City Of Arvada, CO

BUILDING CODE REVIEW

Permit No. COMM22-00132
PLANS CHECKED FOR CONFORMANCE WITH CITY OF ARVADA BUILDING REGULATIONS

EXISTING BUILDING LAY OUT & LOCATION OF CONSTRUCTION

A-3

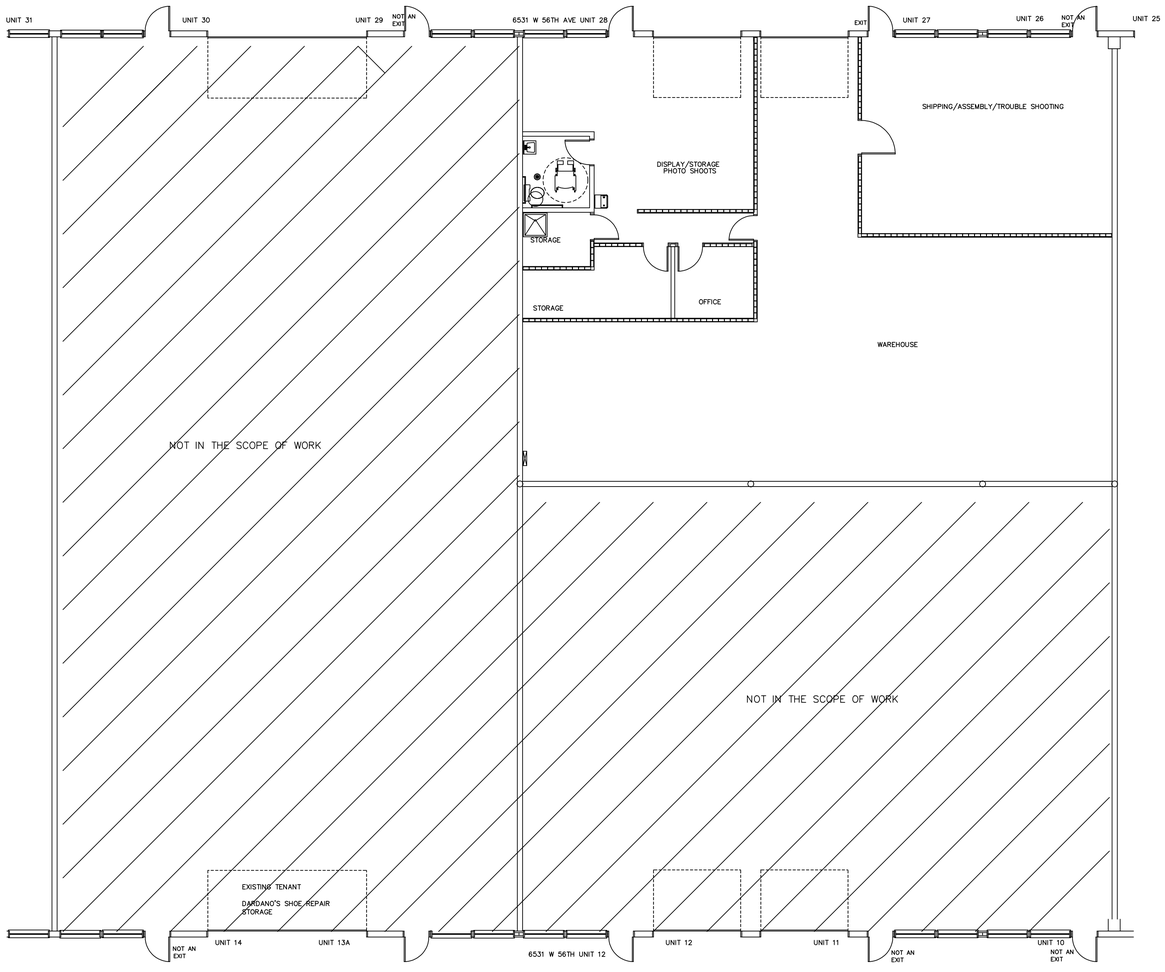
Please show inspector where the service sink is located at inspection. Required per table 2902.1 2018 IBC

A-6

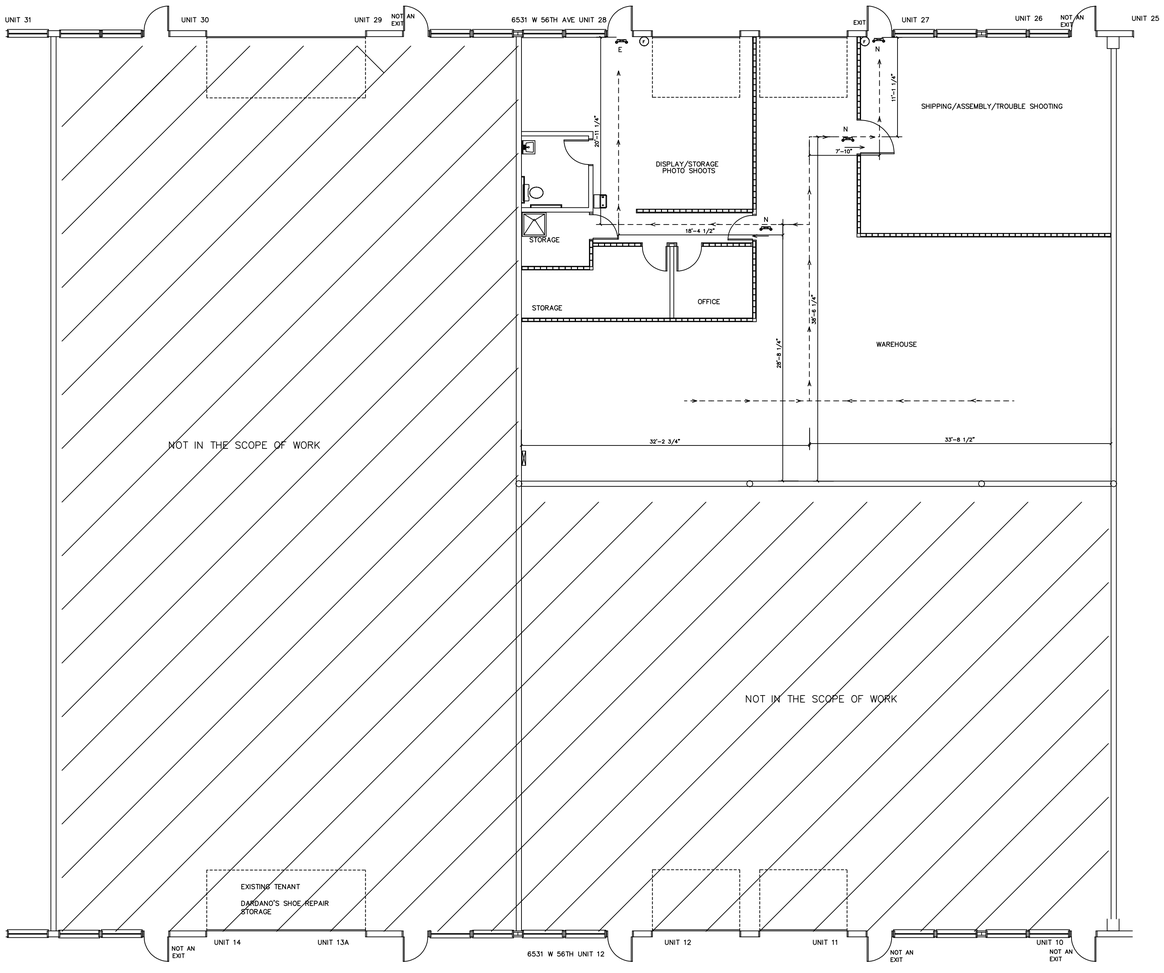
Max travel distance for F1 Sprinklered = 250'
Max common path of Egress travel distance for F1 Sprinklered = 100'
